AREVA Federal Services LLC
Draft Responses to BRR Cask RAIs Issued March 31, 2016

(Note: these responses are intended to facilitate the phone call scheduled for April 7, and do not represent the final response from AREVA Federal Services LLC).

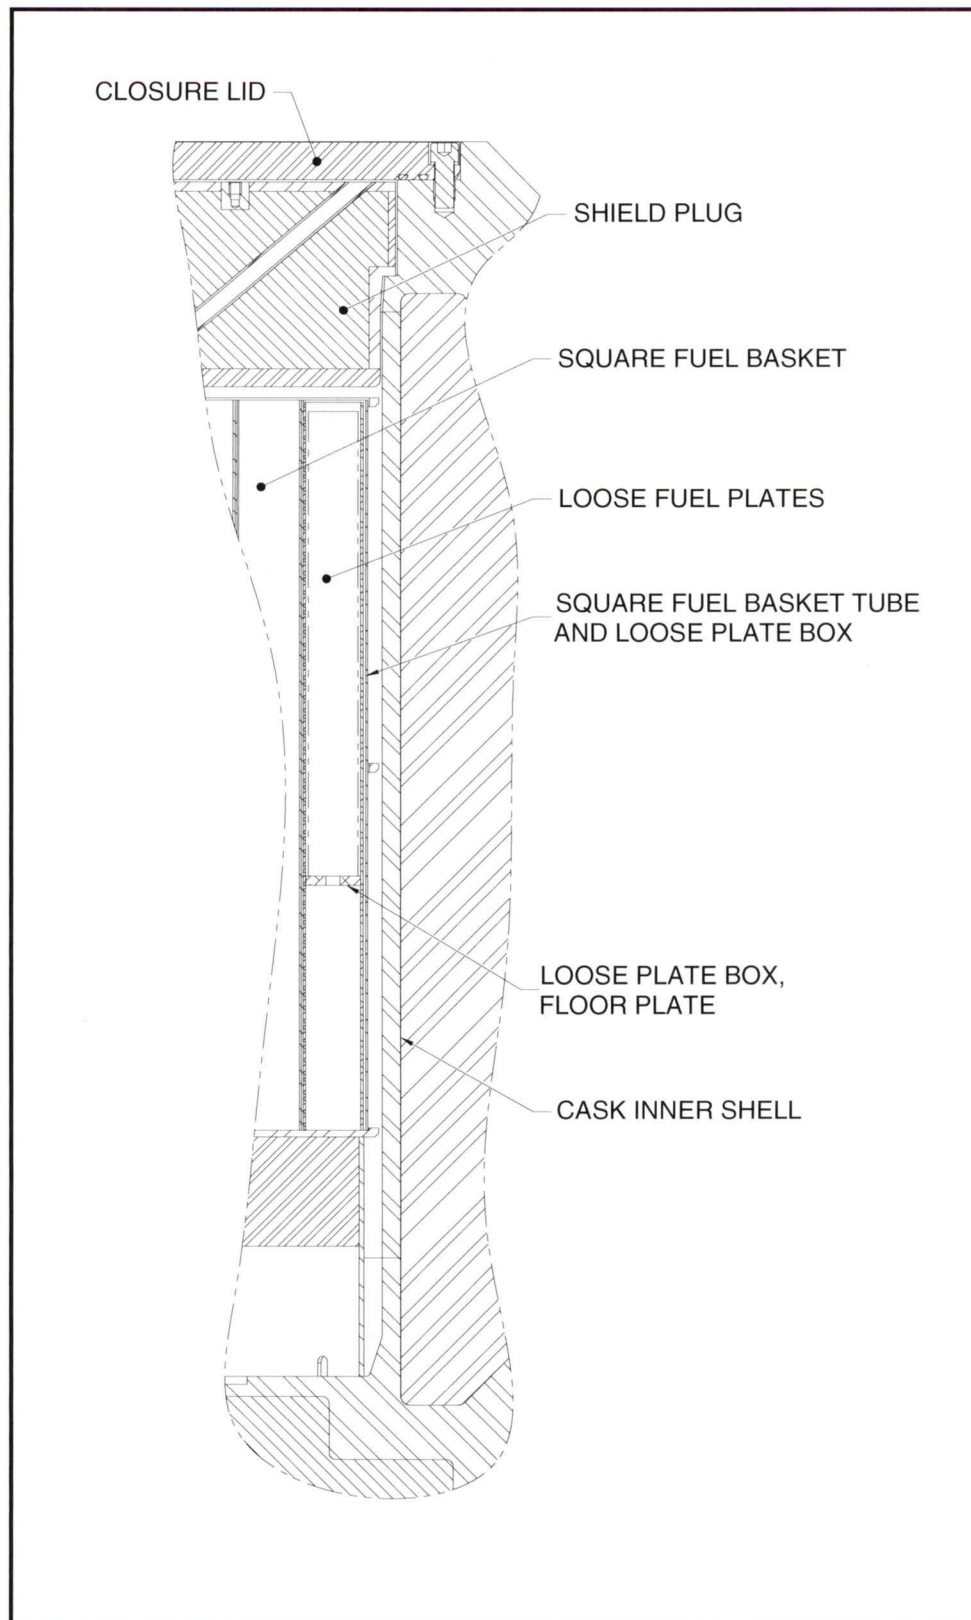
Cr-6-3₂

The loose plate cases were actually run for 5000 neutrons per generation for 250 generations, skipping the first 50. (2500 neutrons per generation is the *minimum* and refers to the original ATR, MITR-II, and MURR cases). A check on Shannon entropy is not available for MCNP5.1.30, which is the version of MCNP used in the SAR. To check the Shannon entropy for each case would require redoing the benchmarking for a later version of MCNP, generating a new USL, and rerunning all of the loose plate cases. The maximum k_s for the loose plate box cases is only 0.648, which is quite low.

The most reactive loose plate box case has been run in MCNP5.1.51 to spot-check the Shannon entropy. For MCNP5.1.51, $k_s = 0.647$ and the Shannon entropy check passed on cycle 2 (see screen shot below). Because k_s is essentially the same between both versions of MCNP, and because k_s is far below the USL, and because the Shannon entropy converged quickly for the most reactive case, the number of cycles used in the SAR analysis is sufficient.
